CITY OF PUNTA GORDA ADA TRANSITION PLAN FINAL REPORT

Laishley Park

October 4, 2017

Figure 4-5 – Ramp to Stage

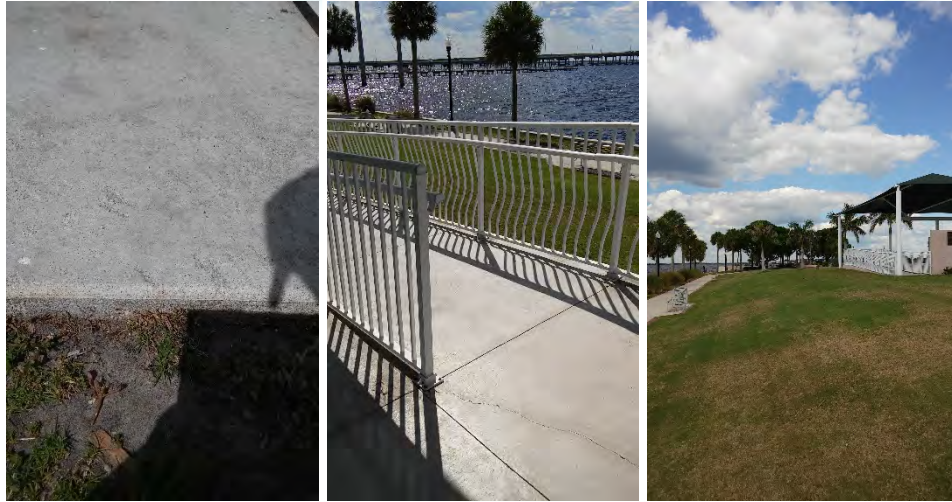
- There is no accessible connection to the stage **ADAAG 302.1**.
 - To access the stage, a visitor needs to either traverse approximately 125' of the Laishley Park great lawn, violating or, make their way over 40' of grass and an embankment that has a running slope of approximately 30%.
 - In addition, there is a 1.5" lip between the cement ramp and the adjacent grass/dirt.
- The south handrail, at the top of the ramp, does not have a handrail extension, violating **ADAAG 505.10**.

ADAAG 302.1 states that, "Floor and ground surfaces shall be stable, firm, and slope resistant."

ADAAG 505.10 states that, "Tamp handrails shall extend horizontally above the landing for 12 inches minimum beyond the top and bottom of the ramp runs."

- Connect the stage's ramp to an accessible route that in turn connects to the accessible parking. This can either be accomplished by paving a route from the southwest for a distance of approximately 125' or by paving a series of switchback ramps from the north.
- Extend the handrail at the top of the stage's ramp to include a 12" minimum handrail extension.

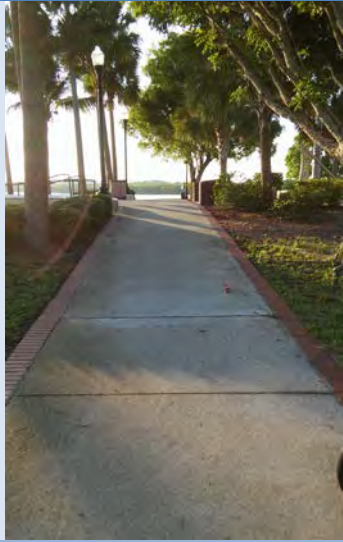
Map Item	Description & Recommendation	Photo(s)
C1	3.3% cross slope – Resurface so the cross slope is no greater than 2%	
C2	3.5% cross slope – Resurface so the cross slope is no greater than 2%	
C3	2.6% cross slope – Resurface so the cross slope is no greater than 2%

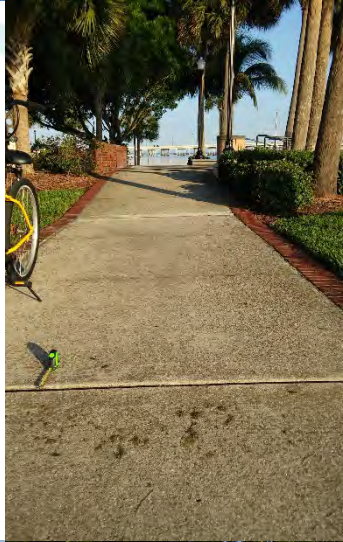
Map Item	Description & Recommendation	Photo(s)
C4	2.1% cross slope – Resurface so the cross slope is no greater than 2%	
C5	3.0% cross slope – Resurface so the cross slope is no greater than 2%	
C6	4.0% cross slope – Resurface so the cross slope is no greater than 2%
